**NOTICE OF ADDENDUM  
ADDENDUM NO. 1**

**CONTRACT NO. 8220**

Revise and amend the contract document(s) for the above project as stated in this addendum, otherwise, the original document shall remain in effect.

PROJECT:  
**WARNER PARK  
 BOAT LAUNCH  
 PARKING LOT  
 RECONSTRUCTION**

**PERMEABLE PAVEMENT CROSS SECTION**

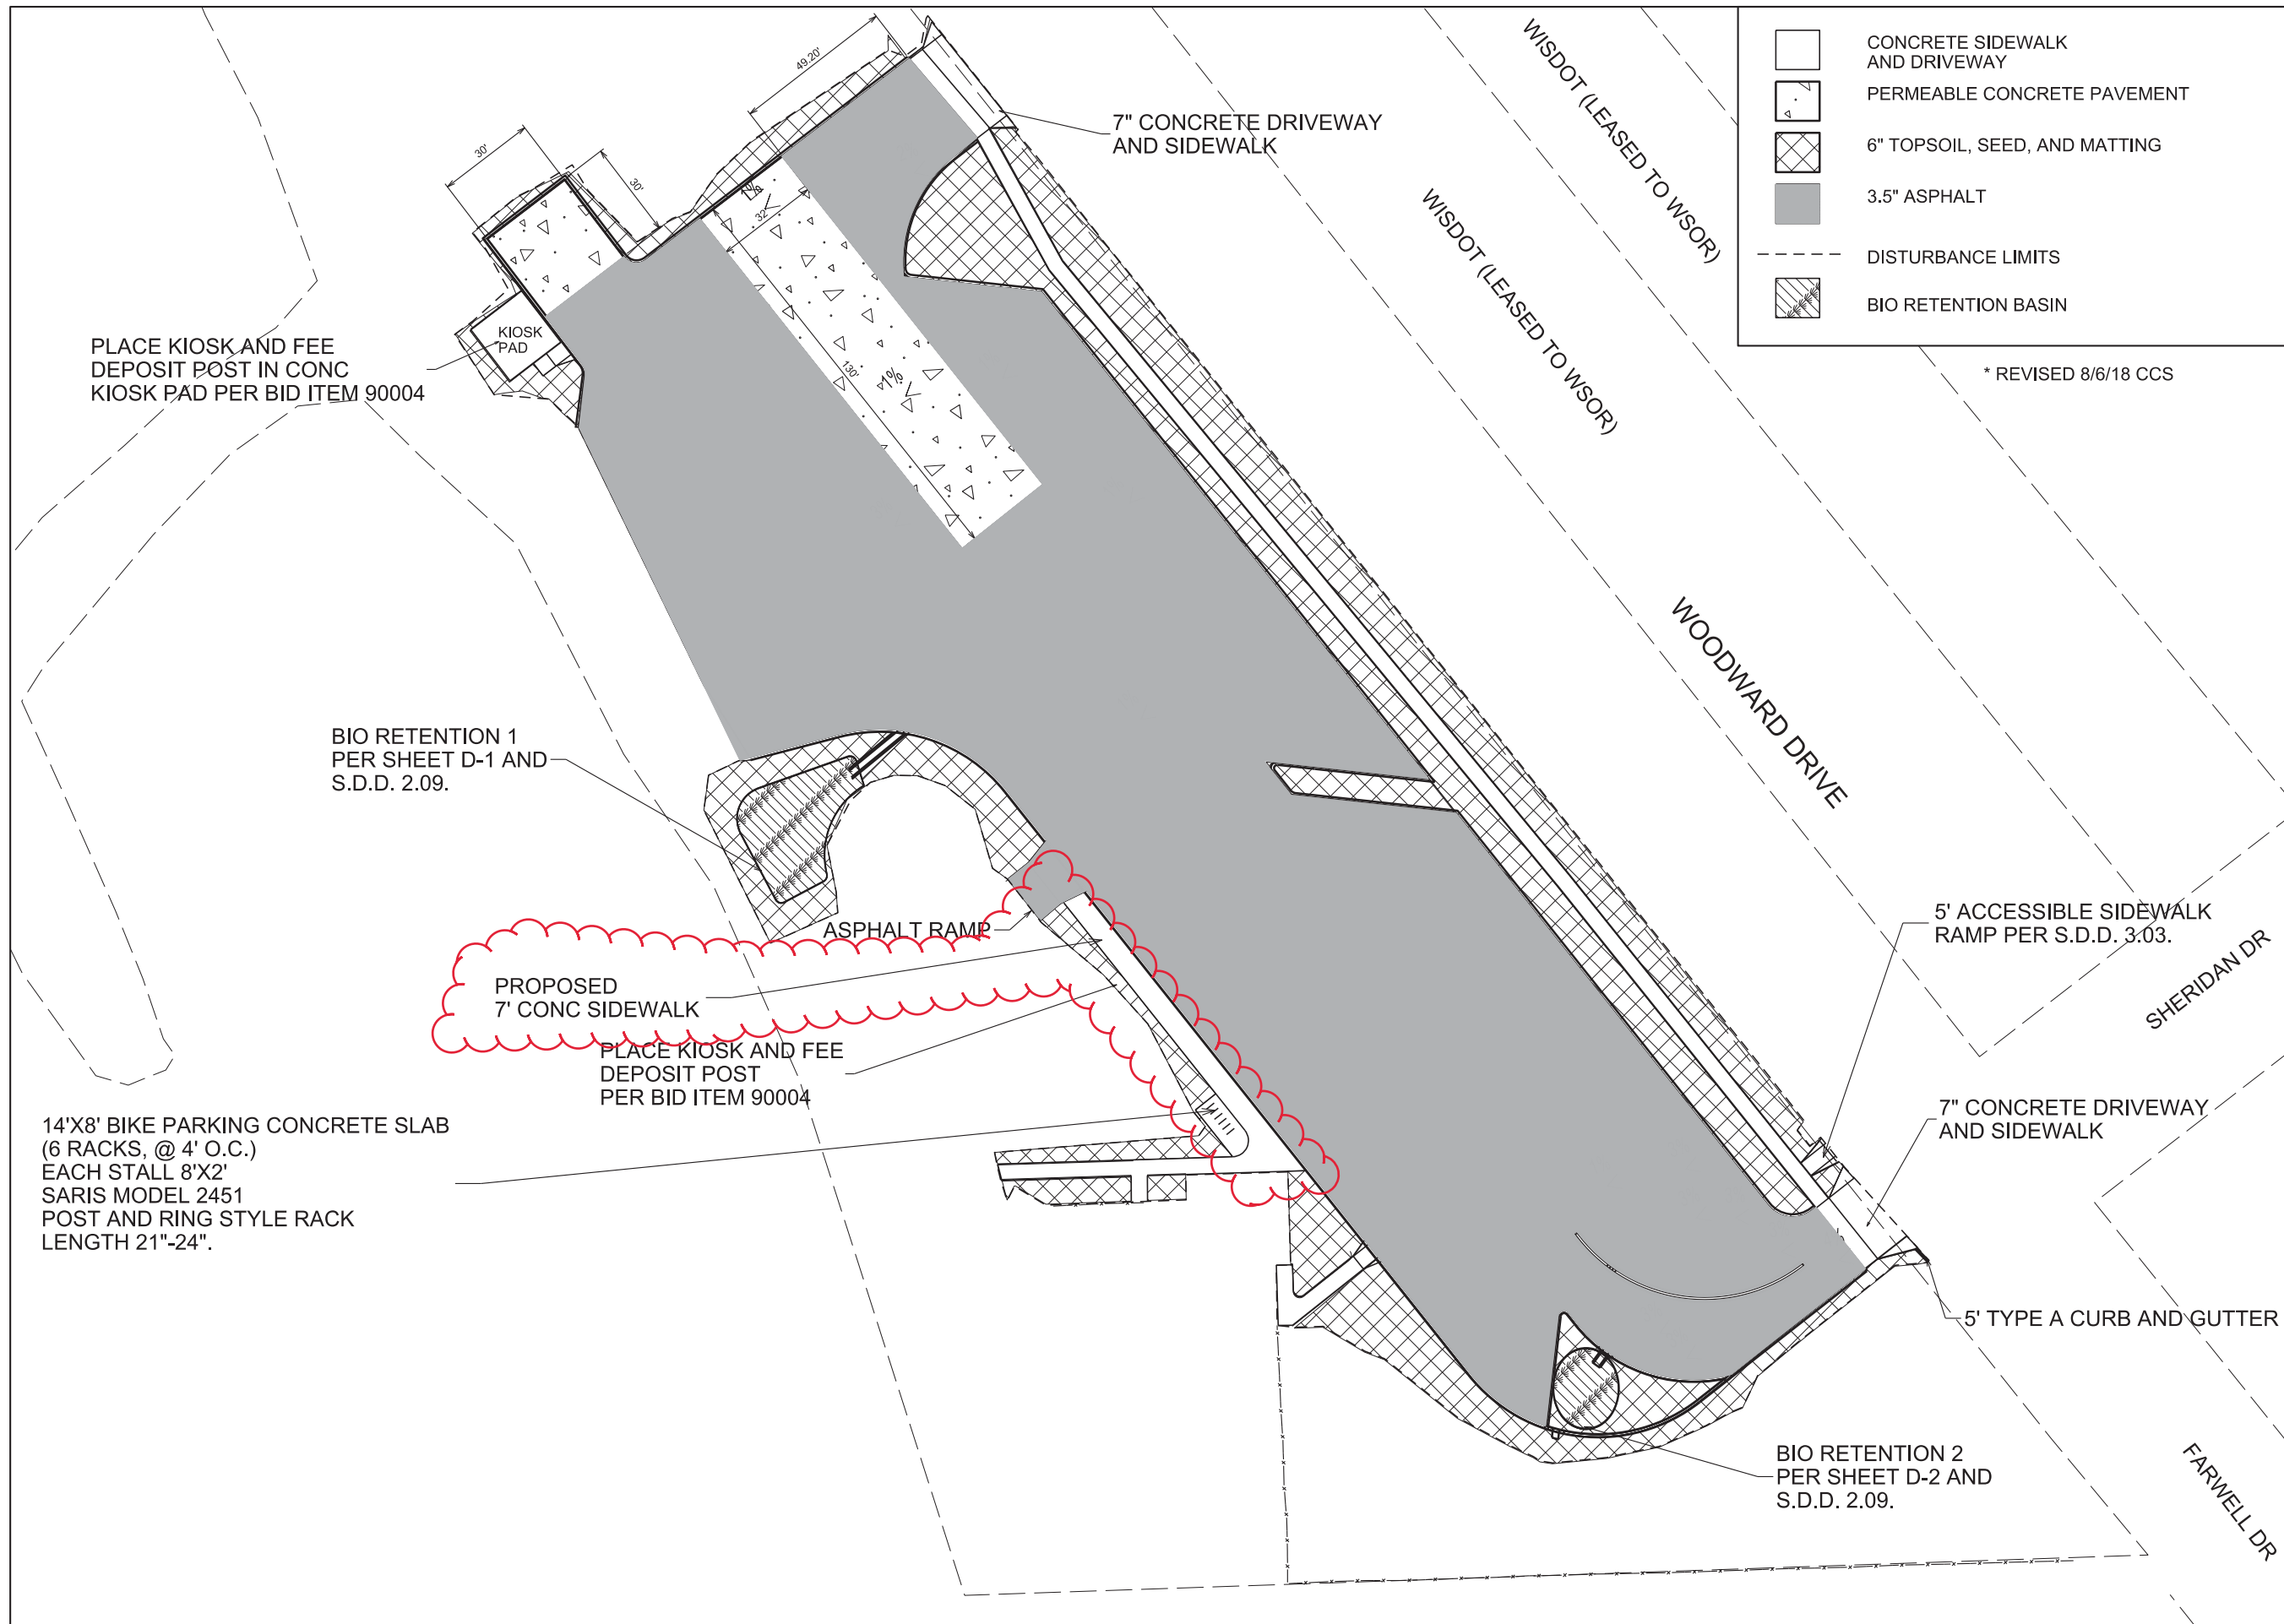
**Revise Page D-2 to show label depths of materials on permeable pavement cross section.**

- ① 12" AGGREGATE STORAGE LAYER
- ② 3.5" HMA 4 LT 58-28 S ASPHALT PAVEMENT
- ③ FILTER FABRIC
- ④ 12" CRUSHED AGGREGATE BASE COURSE GRAD 2; EXTEND 6" BEYOND CURB
- ⑤ 6" TOPSOIL
- ⑥ CURB AND GUTTER
- ⑦ 9" WASHED AGGREGATE BASE COURSE STABILIZATION LAYER
- ⑧ 6" PERMEABLE PRECAST CONCRETE
